**City of Portland, Maine - Building or Use Permit Application**

Permit No: 08-0838	Issue Date: 10/20/08	CBL: 197 B019001
-----------------------	-------------------------	---------------------

Past Use: Vacant Land Parking Lot	Proposed Use: Commercial - TD BankNorth - New 3,000 sq ft building w/ 2 drive up lanes, 64' 7" x 46' 2" & 27' high	Permit Fee: \$9,595.00	Cost of Work: \$950,000.00	CEO District: 3
		FIRE DEPT: <input checked="" type="checkbox"/> Approved <input type="checkbox"/> Denied	INSPECTION: Use Group: B Type: SB IBC 2003

To: Chris Hanson  
From: Jennifer Roy  
Project: TDBN- Portland ME- Westgate Plaza  
Re: Plan Review Questions and Responses  
Distribution: JR, SKD, SSS, Emily Clark (MF)

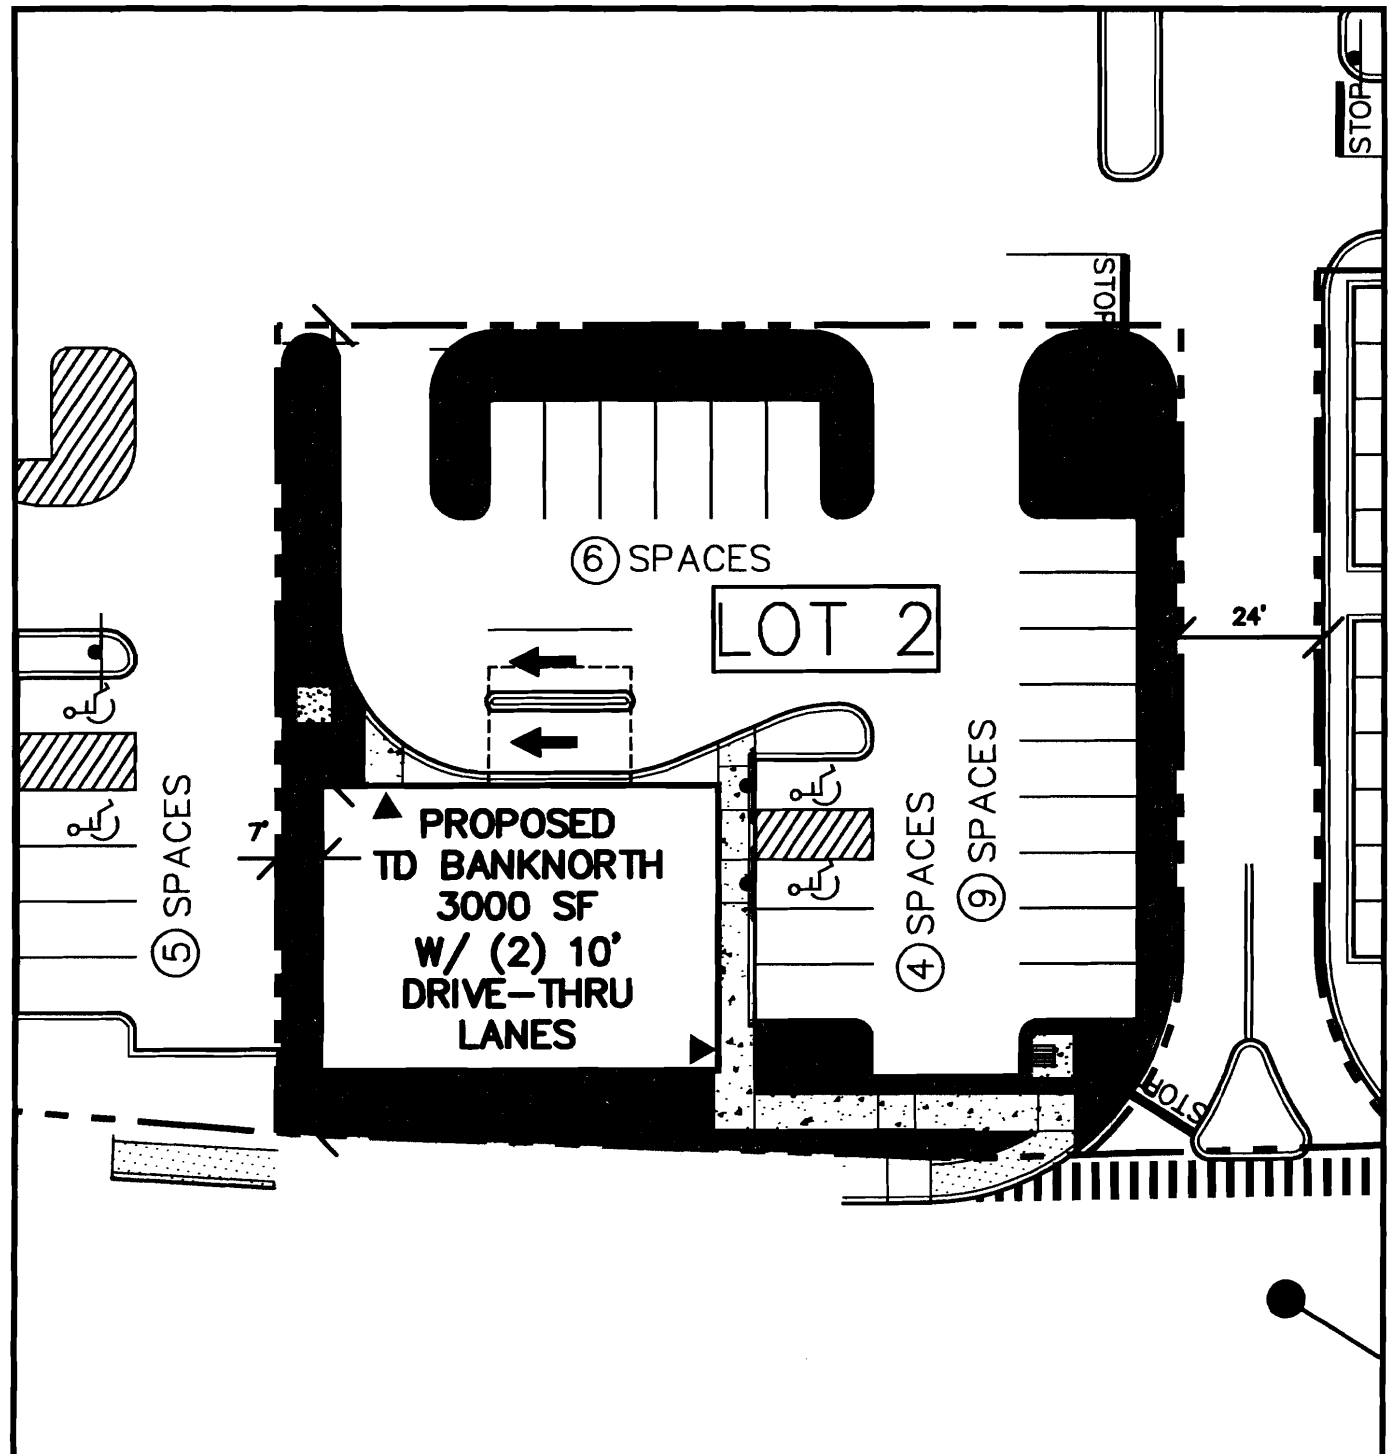
The applicant has e-mailed me revised figures and a colorized version of what was included within the impervious/pervious calculations for THE BANK. I have accepted the areas that are being included within the pervious area and confirmed that the definition of the impervious surface is being met as shown. THE BANK, Lot #2, is meeting all the requirements of the B-2 Zone and can stand alone as meeting zoning requirements as an individual lot if sold off separately.

Thank you Karen for clarifying what was used for the impervious surface calculations. I would accept this revision as meeting the impervious requirements of the B-2 Zone for Lot #2. Admittedly, my calculations were crude and I wanted to confirm what was included within the calculations. You did not include areas that the ordinance does not permit as pervious. I will revise my memo to Molly.

Marge - if you have a chance to review or any questions, please call. Brad has highlighted only those areas counted towards green space as green and has not counted islands that are smaller than 200 sf and we are at 77.48%. This revised sketch also includes the new ramp for the hc and ped access and a minor adjustment in the bike rack location to better facilitate the ramp access, the original plan that you reviewed shows this area at 74.6%. The only lot that was close is Lot 1 which is 79.5% but we have new landscaped islands we are adding which will further reduce the impervious area. The calculations are based on cad drawings which could be provided for verification.

We get 77.5% for the open space on the bank parcel. The areas that we counted are shown in green.

Pervious area: 4333.69 (22.52%)  
Impervious area: 14912.72 (77.48%)  
Lot area: 19246.41
